# RENESAS TECHNICAL UPDATE

Product Category	MPU/MCU		Document No.	TN-RX*-A187A/E	Rev.	1.00
Title	Corrections to Descriptions for the P/E Suspend Command of Flash Memory in RX64M Group, RX71M Group Flash Memory User's Manual: Hardware Interface		Information Category	Technical Notification		
Applicable Product	RX64M Group, RX71M Group	Lot No.	Reference Document	RX64M Group, RX71M Group Flash Memory User's Manual: Hardware Interface Rev.1.10 (R01UH0435EJ0110)		
		All

This document describes corrections to the flow chart of the P/E suspend command in RX64M Group, RX71M Group Flash Memory User's Manual: Hardware Interface Rev.1.10.

**Figure 6.11 Usage of the P/E Suspend Command**

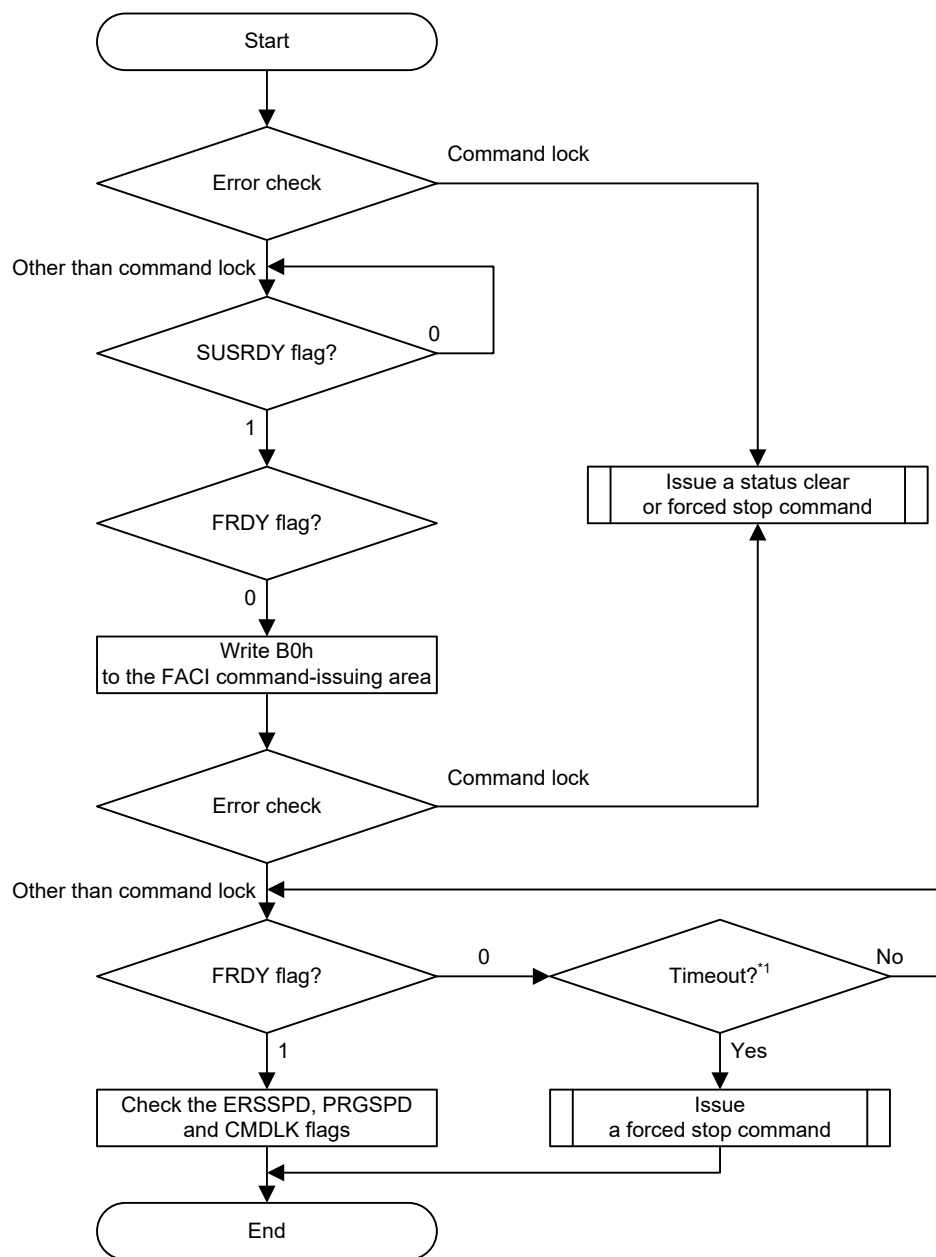
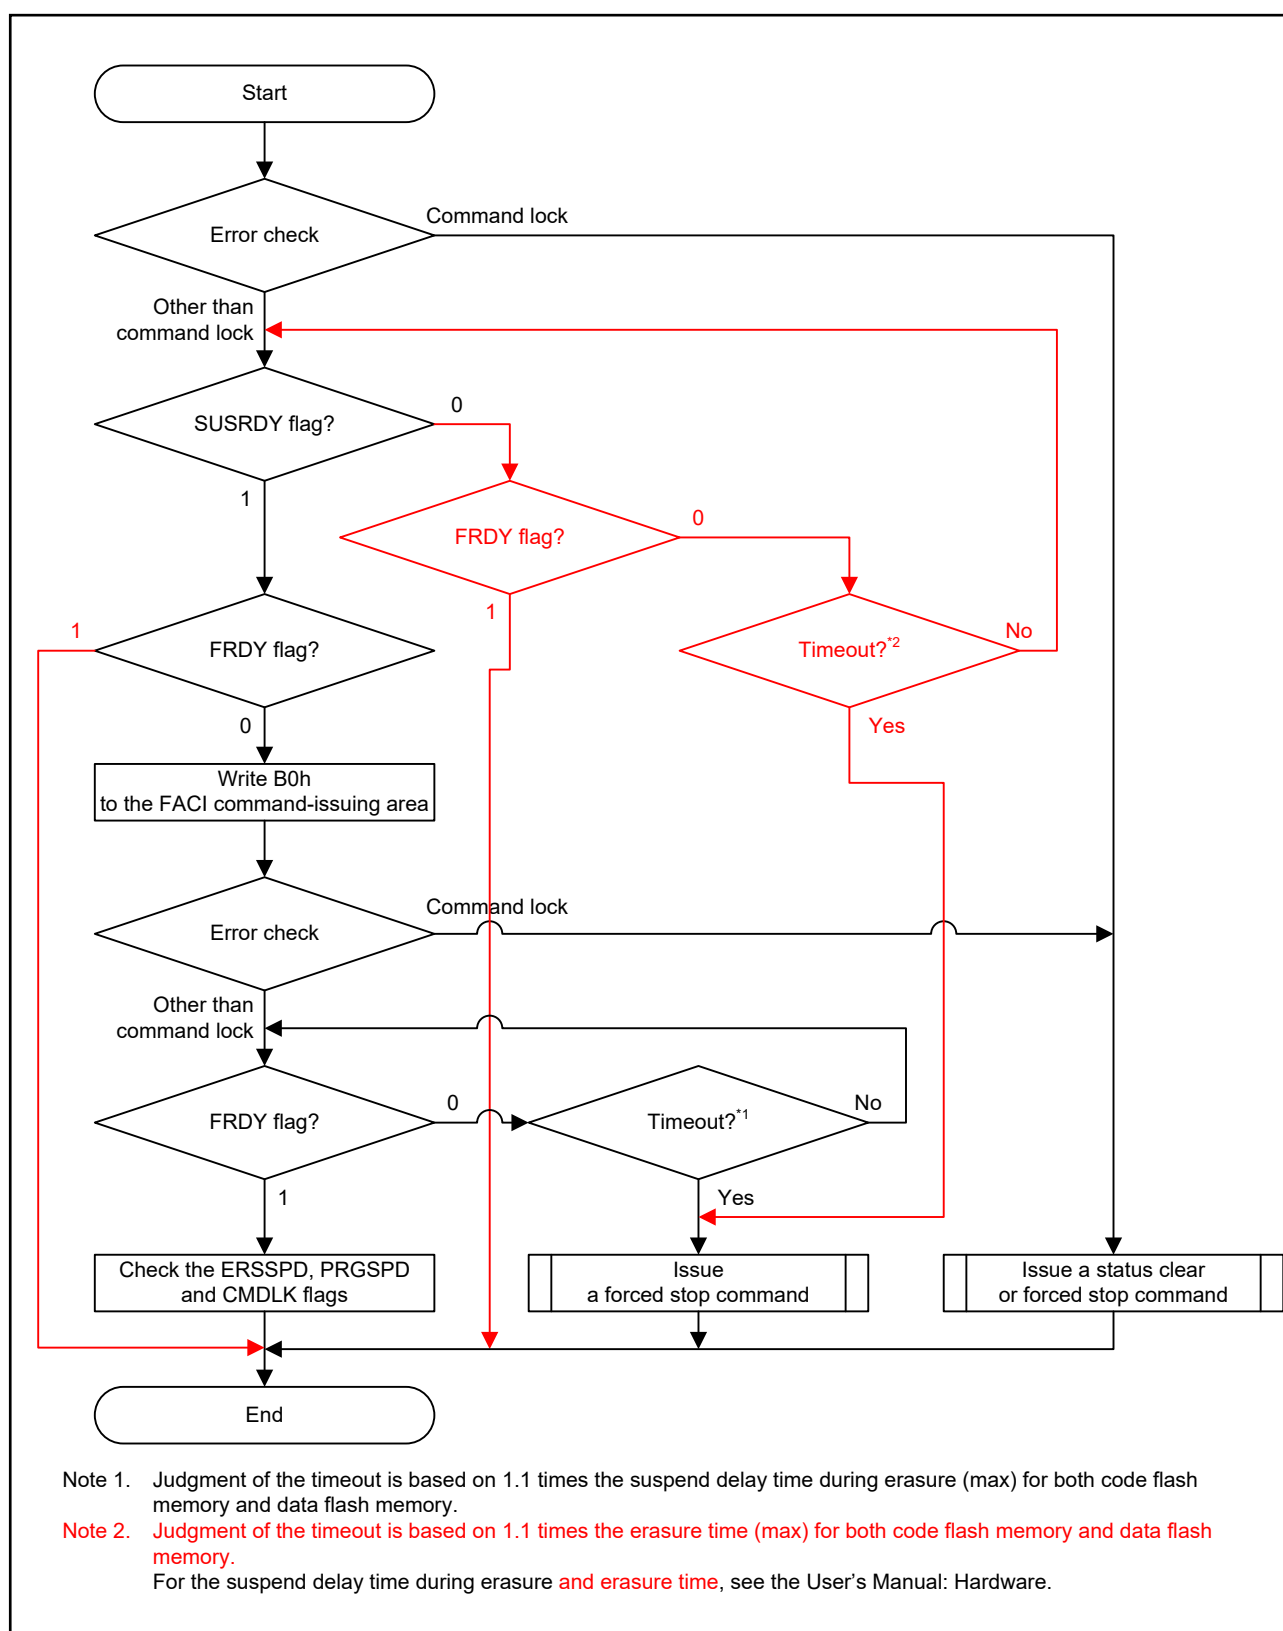
In Figure 6.11, Usage of the P/E Suspend Command, a processing flow never escapes from the loop for a checking procedure if the program/erase processing completed before checking the SUSRDY flag.

Therefore, a timeout processing and a breaking processing when the FRDY flag is 1 are to be added.

Note 1. Judgment of the timeout is based on 1.1 times the suspend delay time during erasure (max) for both code flash memory and data flash memory.  
For the suspend delay time during erasure, see the User's Manual: Hardware.
